11 July 2022

AMENDMENT TO SSD-10272349 YIRIBANA LOGISTICS ESTATE

Amended Project Description

Figure 1 Refinement to the exhibited project – Site Layout Plan

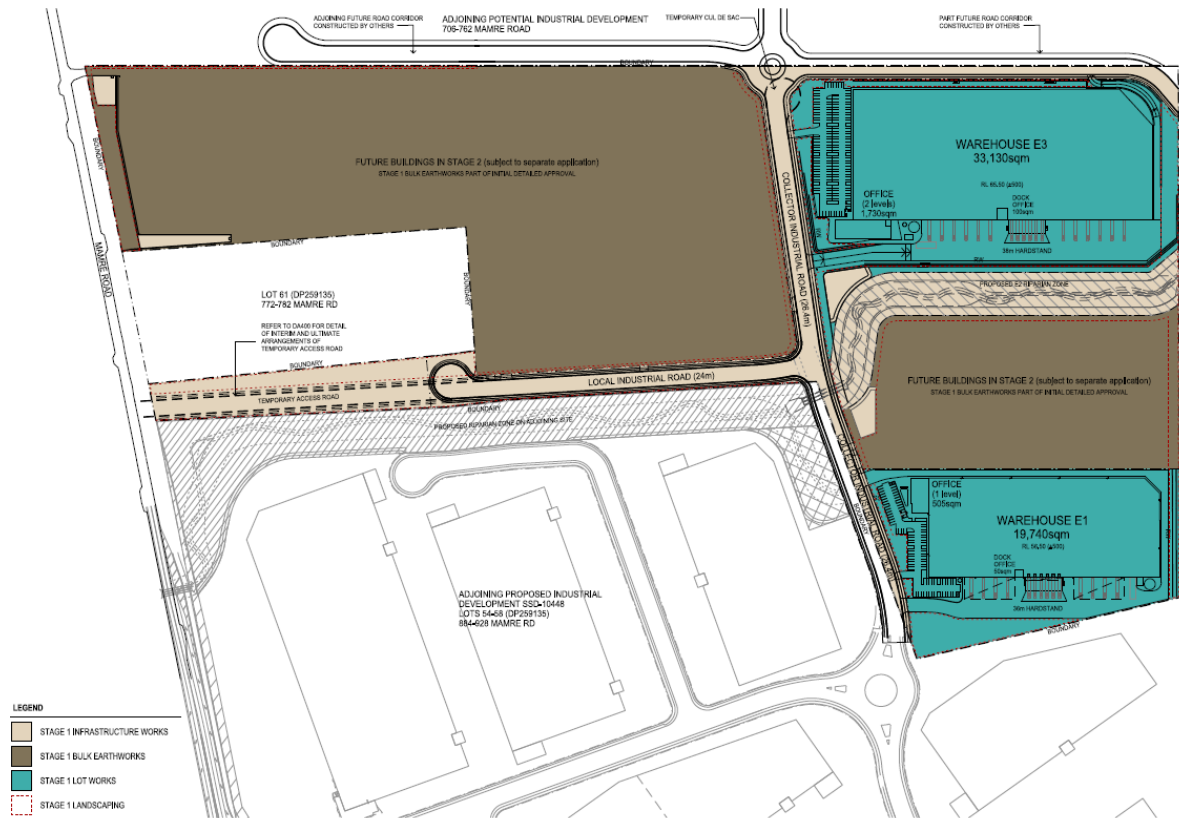
The amendment to SSD-10272349 is for the withdrawal of the Concept Master Plan from the application, with only the Stage 1 development (now referred to as the '**Site Layout Plan**') works to remain. The Concept Master Plan comprised a total of five (5) warehouses, three (3) of which (warehouse 2, 4 and 5) were proposed for concept approval and two (2) (warehouses 1 and 3) for Stage 1 approval.

As a result of this amendment to SSD-10272349, the project description is updated to reflect the following:

Figure 2 Proposed YLE Warehouse 1 Site Plan

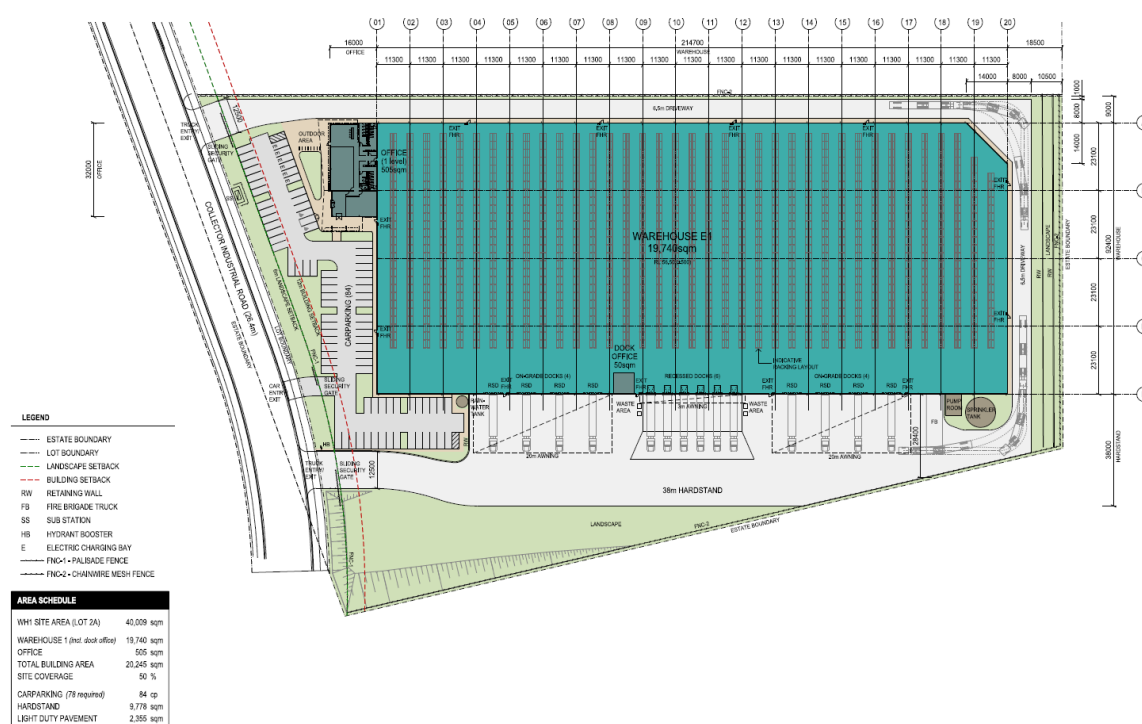
- **Warehouse and distribution building works** including:
 - Warehouse 1 (Lot 2A) (refer **Figure 2**)
 - Detailed on-lot earthworks to refine final levels and establish final building pads;

- On-lot stormwater and utility infrastructure and services connection;
 - Construction of warehouse building as shown on the detailed Architectural Plans;

- Fit out of buildings as shown on detailed Architectural Plans, including standard racking and office fit out; and
 - Landscaping of development sites in accordance with detailed Landscape Plans.

Figure 3 Proposed YLE Warehouse 3 Site Plan

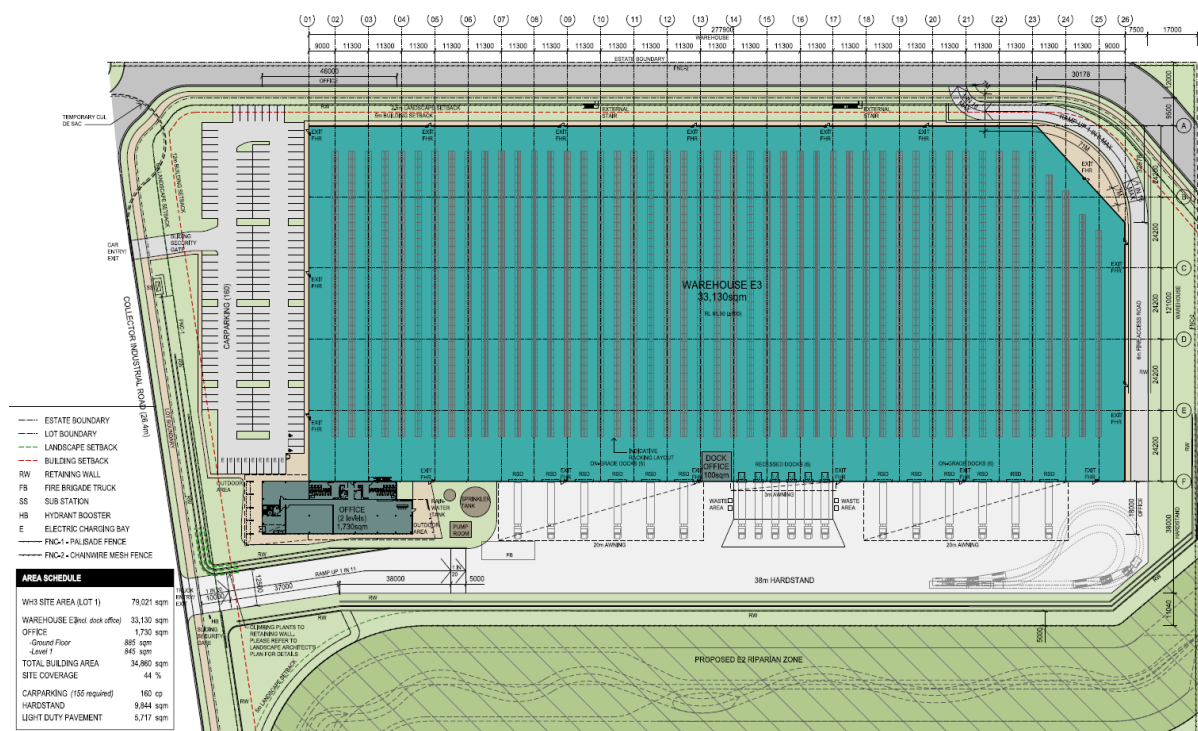
- Warehouse 3 (Lot 1) (refer **Figure 3**)
 - Detailed on-lot earthworks to refine final levels and establish final building pads;
 - On-lot stormwater and utility infrastructure and services connection;

- Construction of warehouse building as shown on the Stage 1 Architectural Plans;
 - Fit out of buildings as shown on Stage 1 Architectural Plans, including standard racking and office fit out;

- Landscaping of development sites in accordance with Stage 1 Landscape Plans; and
 - Reconstruction of environmental corridor in accordance with the Vegetation Management Plan (VMP) (Appendix T).

Figure 5 Proposed E2 riparian corridor

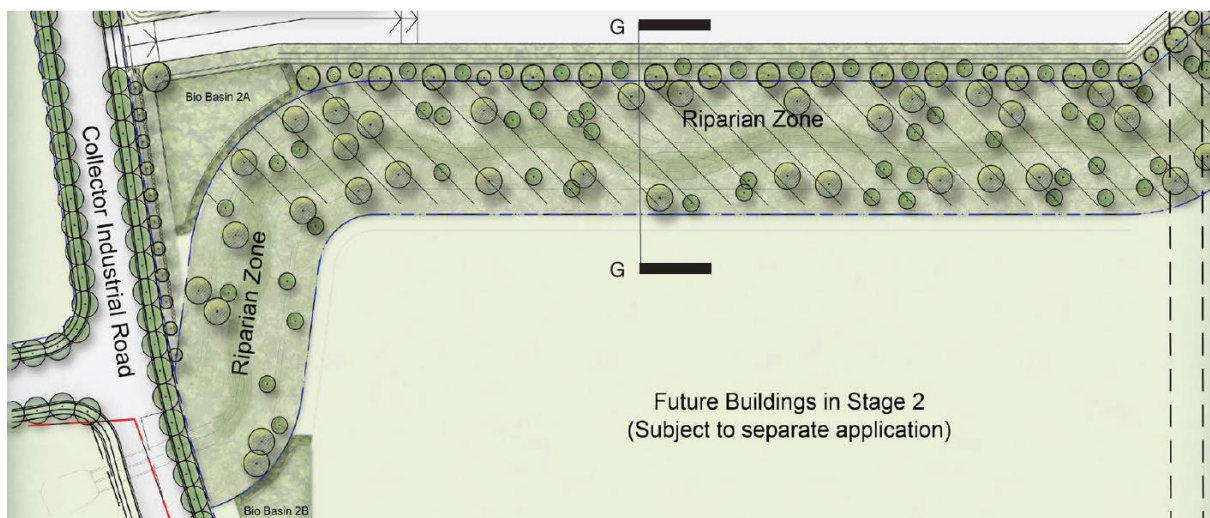
The E2 riparian corridor within the site connects from the adjoining property owned by Dexu to the east, through the eastern portion of the site, and into the Mirvac site to the south-west of the GPT site. As part of the EIS, a 25m wide riparian corridor was proposed, with 5m setbacks on either side. However, following feedback from the agency and public authority submissions and through a meeting with NRAR, GPT proposed to widen the E2 riparian corridor to 40m, with 5m setbacks on either side, in order to comply with NRAR's minimum requirements and recommendations.

The total area of the E2 riparian corridor has increased from 9,697 m² in the EIS to 15,393 m² within the updated Master Plan within this Submissions Report (refer **Figure 5**).

The project description has also been amended to incorporate the realignment of the existing E2 zone which is supported through consultation with NRAR. The realigned riparian corridor will maintain the existing width of 40m and supported by landscaping.
